COMBUSTIBLE LIQUID DELIVERY AND STORAGE TANK DESIGN REVIEW FOR COMPLIANCE TO AS 1940, BARANGAROO BUILDING C1

REPORT VERSION – 1.1

OUR REFERENCE: CN181175

DATE: 26 MARCH 2019

Figure 1: Cut-out from LendLease Drawing AD0000008 showing location of proposed tank (upper yellow mark) and proposed filling point

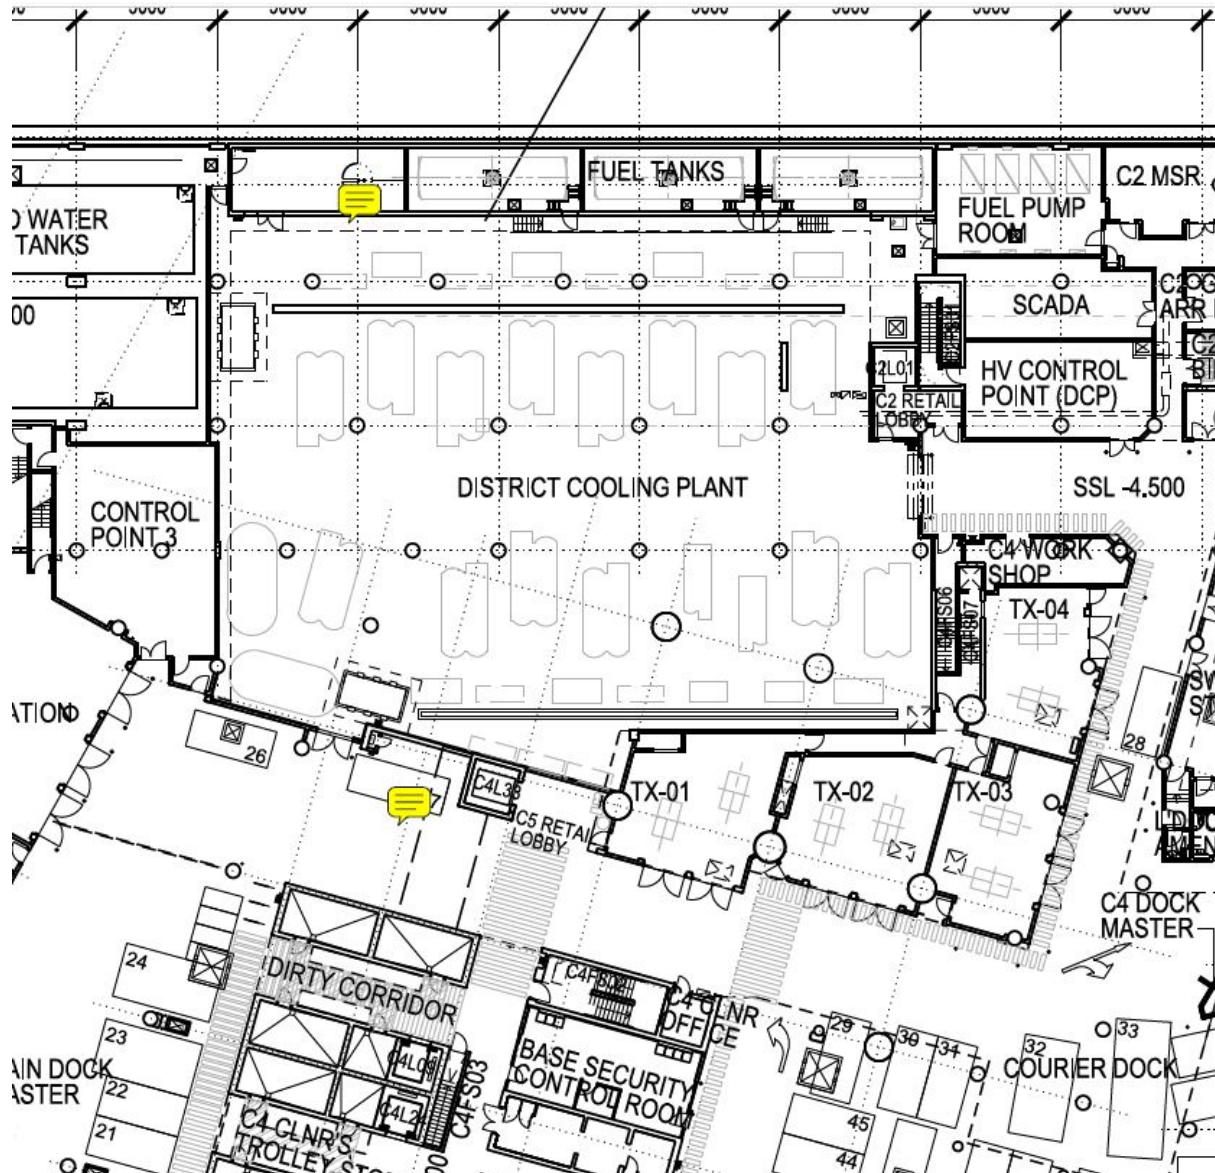
A cut-out drawing showing the location of the tank and the fill point is shown in Figure 1.

The Fuel Pump Room is shown in the top right area of Figure 1. Extending to the left of this in the figure are four rectangular areas indicated as “Fuel tanks”. The figure shows the outline of three tanks which are understood to represent the existing diesel tanks and to the left of them, indicated by the yellow mark, is the chamber in which the tank of vegetable oil is to be located. In previous drawings this area was indicated as the Green Utility Workshop.

In the earlier CETEC report (CN150120⁵) it was accepted that the walls indicated to be enclosing the four rectangular areas to the left of the Fuel Pump Room in Figure 1 are loadbearing walls and columns having an FRL of 240/240/240. CETEC assumes that this is still the case, and that the doors, floors and ceilings are also as accepted in that report. It was accepted in that report that the tanks were to be located (as they now are) in ‘tank chambers’.

[CETEC comment:](#) it’s understood from email correspondence with the client that the area proposed for the new vegetable oil storage tank, described in earlier drawings as the “Green utility workshop” (Code C2B2G02 in those drawings) will be restored to its original design so that it then has the same containment capacity, and the same fire ratings for penetrations, doors, walls and ceiling, as the three current diesel storage areas (Fuel Tank Rooms No. 1, 2 and 3, Codes C2B2E02, C2B2E03 and C2B2E04 in Drawing BB1AD1062200, Revision S). If so, then the enclosure is already adequately bunded for a tank containing combustible liquid of 20,000 L capacity, even if it was to contain an additional tank, as

proposed, of a non-hazardous aqueous solution of urea of 3,500 L capacity, with the tank possibly displacing as much as 5,000 L. If the enclosure is indeed to be restored to being an adequately bunded area then this adequacy would need to include the volume of the bund being sufficient to preclude any possibility that the simultaneous loss of containment of the urea solution tank and the vegetable oil tank, along with 20 minutes of full discharge of fire sprinklers, could cause the bund to overflow.
